## September 2024 ERRATA for *AASHTO Guide Specifications for LRFD Seismic Bridge Design, 3rd Edition* (LRFDSEIS-3)

AASHTO has issued an erratum, which includes technical revisions, for *the AASHTO Guide Specifications for LRFD Seismic Bridge Design, 3<sup>rd</sup> Edition* (LRFDSEIS-3).

Figure 3.3-1a—Permissible Earthquake-Resisting Systems (ERSs)

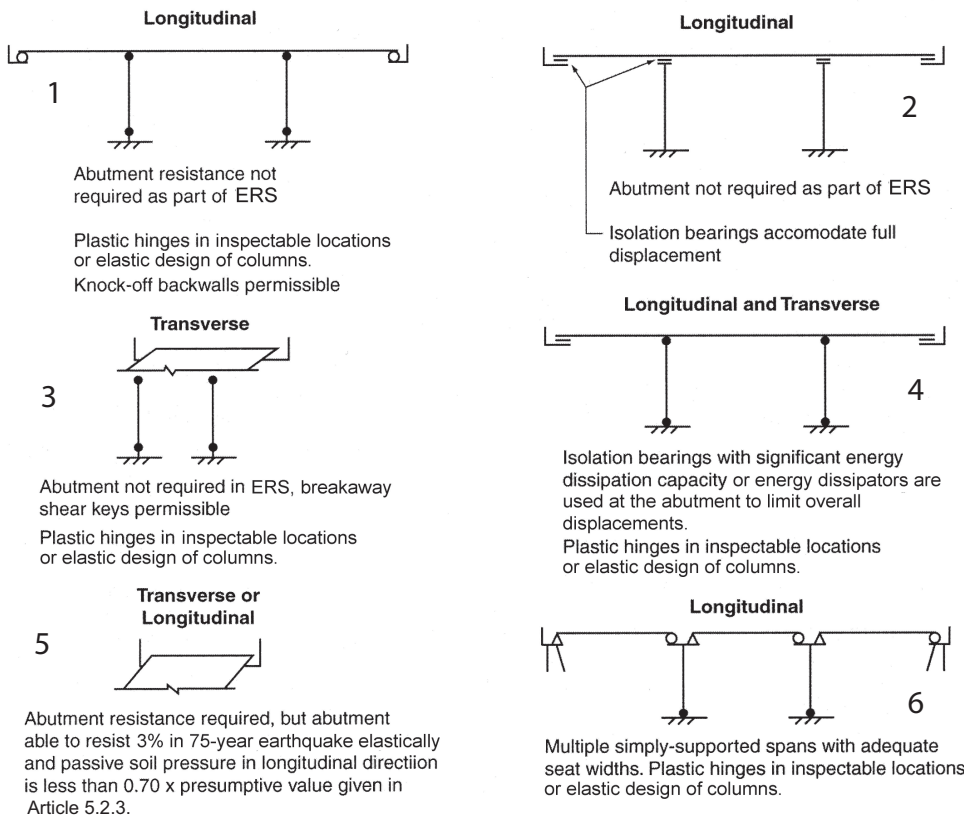
3-10	Figure 3.3-1a	Individual items in the figure should be numbered.	<p>1 Abutment resistance not required as part of ERS Plastic hinges in inspectable locations or elastic design of columns. Knock-off backwalls permissible</p> <p>2 Abutment not required as part of ERS Isolation bearings accommodate full displacement</p> <p>3 Abutment not required in ERS, breakaway shear keys permissible Plastic hinges in inspectable locations or elastic design of columns.</p> <p>4 Isolation bearings with significant energy dissipation capacity or energy dissipators are used at the abutment to limit overall displacements. Plastic hinges in inspectable locations or elastic design of columns.</p> <p>5 Abutment resistance required, but abutment able to resist 3% in 75-year earthquake elastically and passive soil pressure in longitudinal direction is less than 0.70 x presumptive value given in Article 5.2.3.</p> <p>6 Multiple simply-supported spans with adequate seat widths. Plastic hinges in inspectable locations or elastic design of columns.</p>

Figure 3.3-2—Permissible Earthquake-Resisting Elements that Require Owner’s Approval

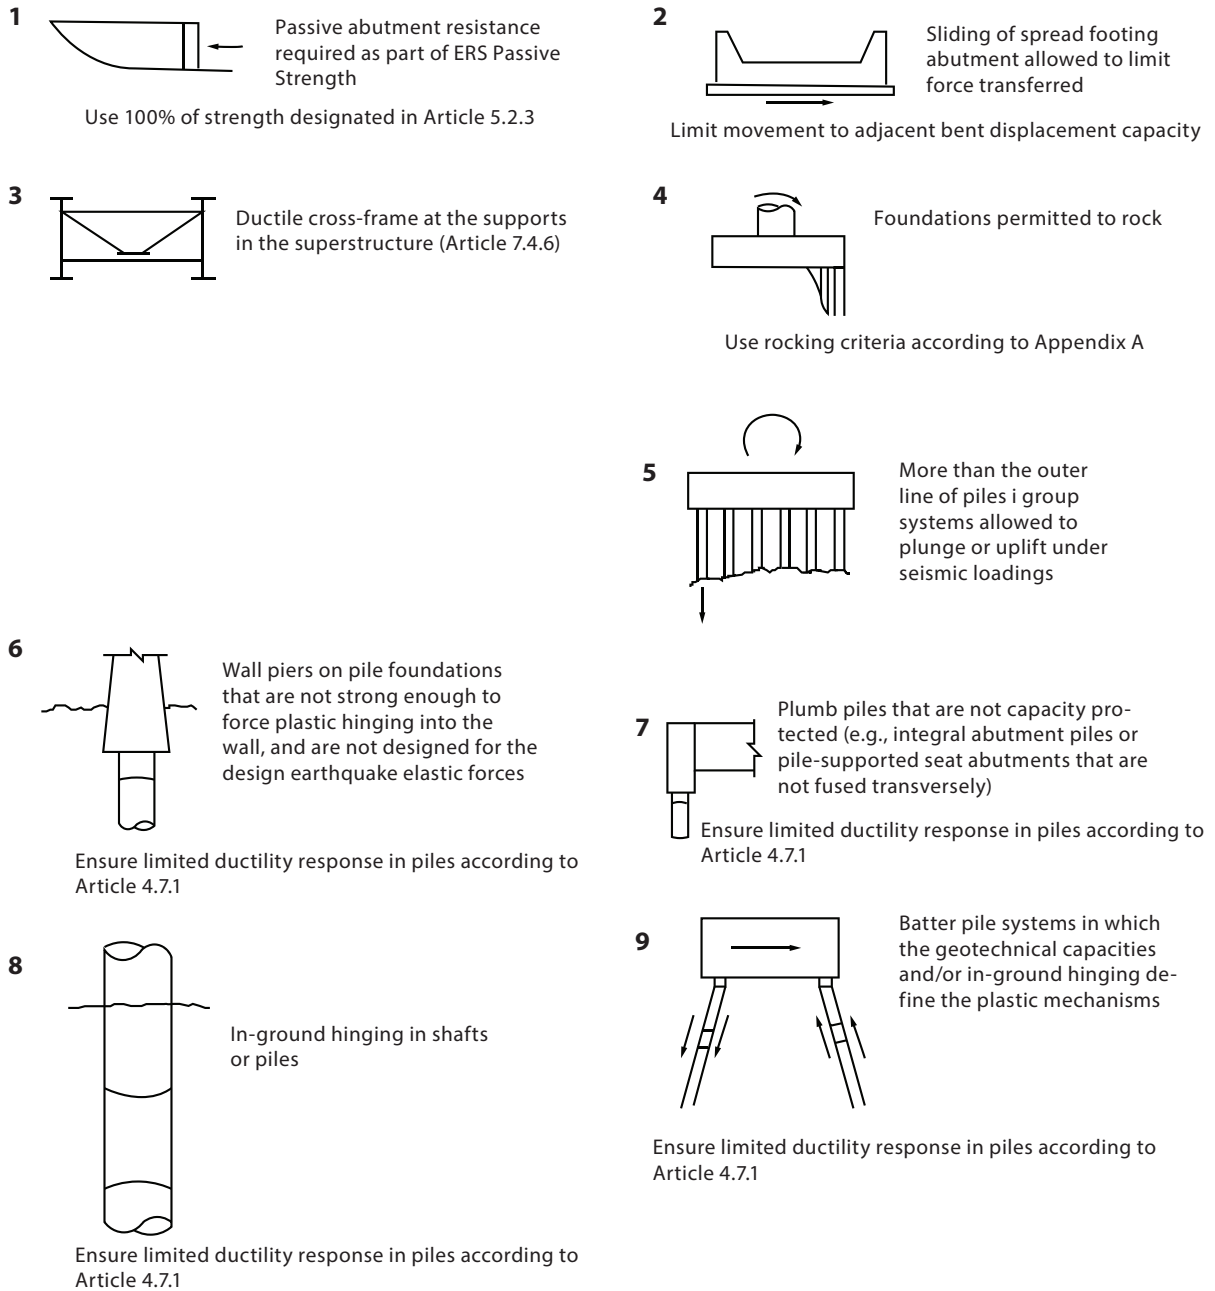
3-13	Figure 3.3-2	Item 3 in the figure's label has been changed from "Ductile end diaphragms in superstructure" to "Ductile cross-frame at the supports in the superstructure".	<p>3 Ductile cross-frame at the supports in the superstructure (Article 7.4.6)</p>
